REMARKS

Claims 1, 3 and 5 have been amended, claims 2, 7 and 13 – 23 have been canceled without prejudice and claims 62 - 73 have been added. Claims 1, 3 – 6, 8 - 12 and 24 -73 remain pending in the application. The Examiner is respectfully requested to re-consider his rejections.

Fig. 5

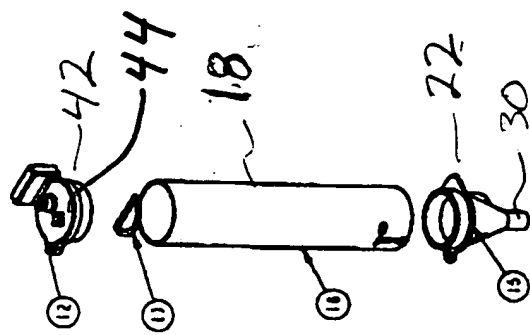
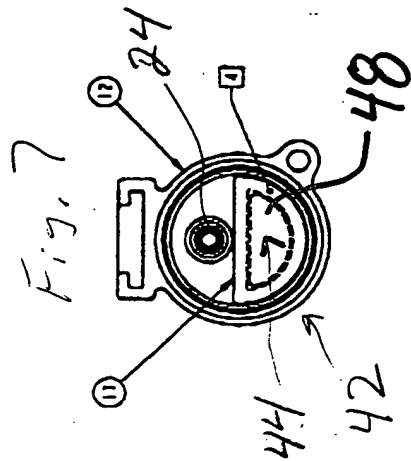
The Examiner has objected to the drawings under 37 C.F.R. 1.83(a) because they fail to show "the filter being flush with the outer surface of the volume reservoir" as described in the claims. Submitted herewith is a redline version of Figure 5 with the label "44" added to show the location of the filter material 44. Support for this addition is found in Figures 6 and 7. As can be seen, filter material 44 is flush with the outer surface of the volume reservoir. No new matter has been added. Therefore, the Examiner is respectfully requested to reconsider his '83(a) objection. Should the Examiner accept the submitted redline versions of Figures 5 and 7, the Applicant will prepare and submit formal drawings for the instant application incorporating the proposed changes.
